TRANSMITTAL OF SHOP DRAWINGS, EQUIPMENT DATA, MATERIAL SAMPLES, OR
MANUFACTURER'S CERTIFICATE OF COMPLIANCE

TRANSMITTAL NO.
TO 022-007

Comments on:
**GEC (Gulf Engineers & Consultants)
 Sediment Sampling and Analysis Plan**
 Lakes District,
 City/Parish of East Baton Rouge, Louisiana

**FINAL SITE ACTIVITIES AND SOIL CLASSIFICATION
REPORT
PHASE II ENVIRONMENTAL SITE ASSESSMENT
OAKVILLE LEVEE EXTENSION
PLAQUEMINES PARISH, LOUISIANA**

Borehole 3 (B3) Depth (inches)

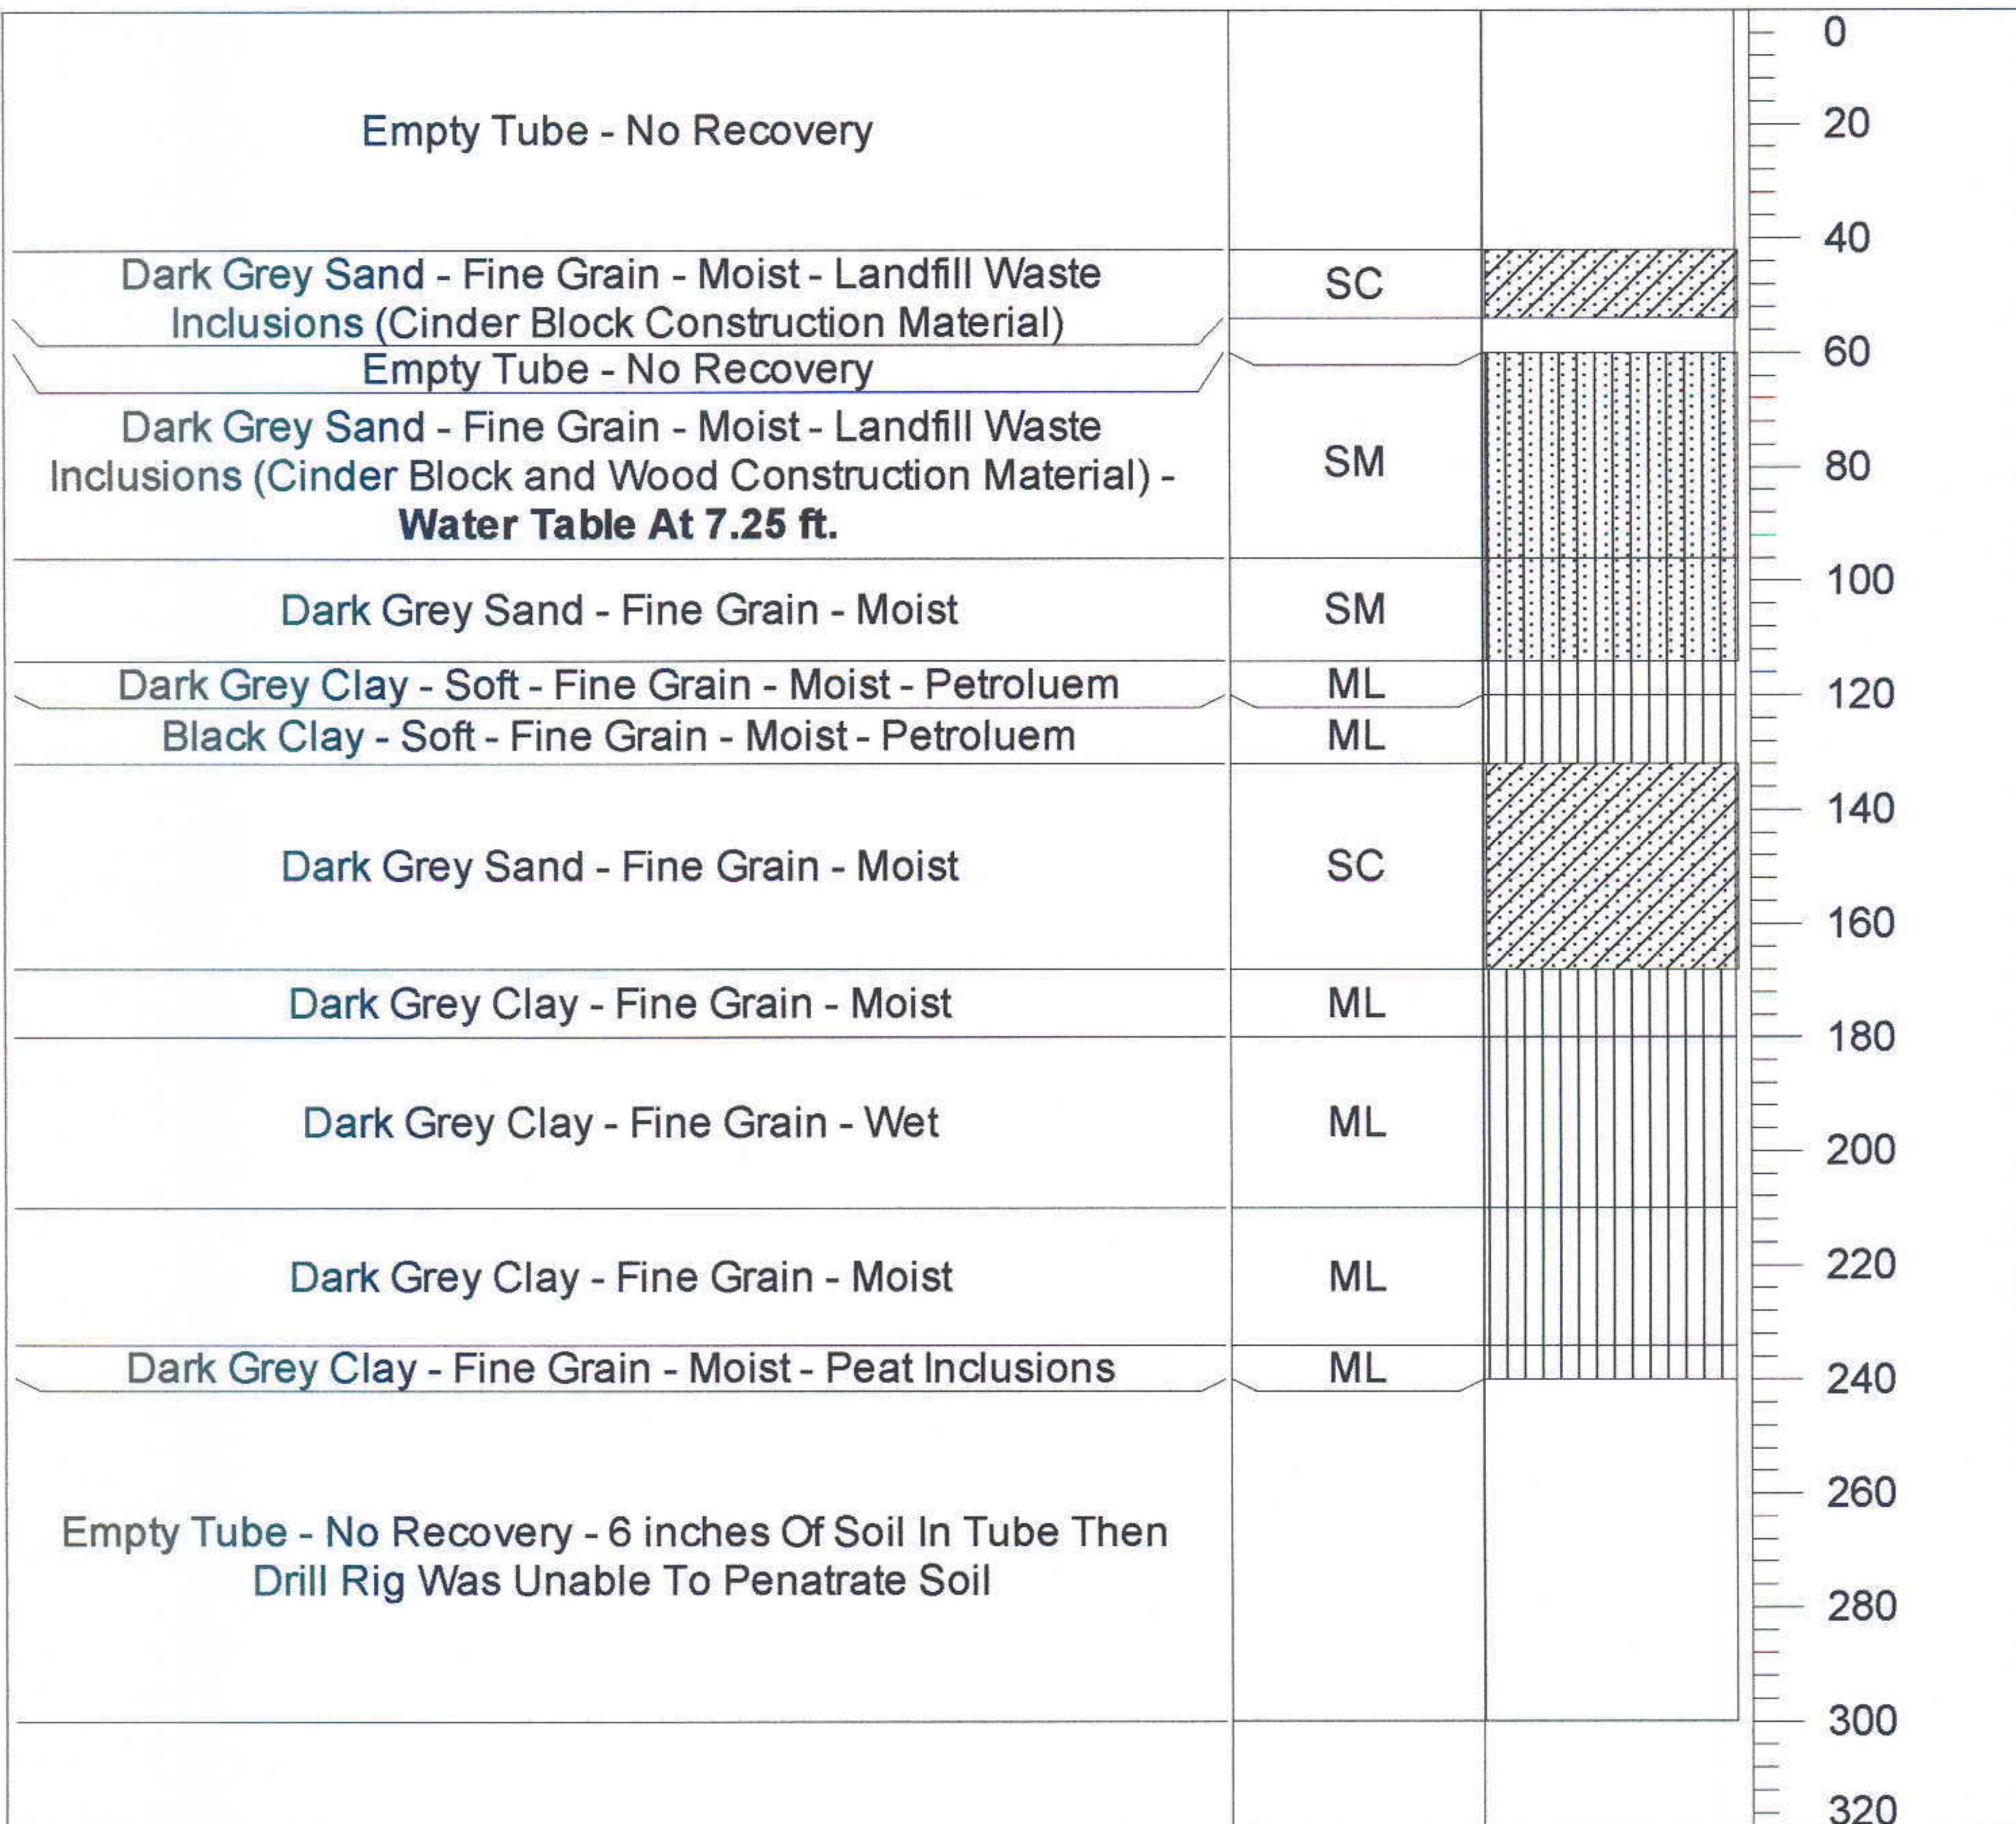
2 (Bacuta)	General	General	Please describe the pieces of landfill-related debris material found in Boring #3 and Boring #4. Are these recognizable pieces of construction/demolition debris? household debris? White trash? etc. Attachments of close-up photos of these debris pieces are strongly recommended.	C	Added debris descriptions to the appropriate boring logs (B3 and B4). In addition, added to report text: Section 3.1.2, added last sentence to paragraphs for B3 and B4. Revised photolog to reflect descriptions of debris.
3 Brooks	Soil Boring Logs		RE above comment #1: SOW Paragraphs D.2. & G. c. require soil classification in accordance with the USCS and ASTM	C	See response to comment #1.
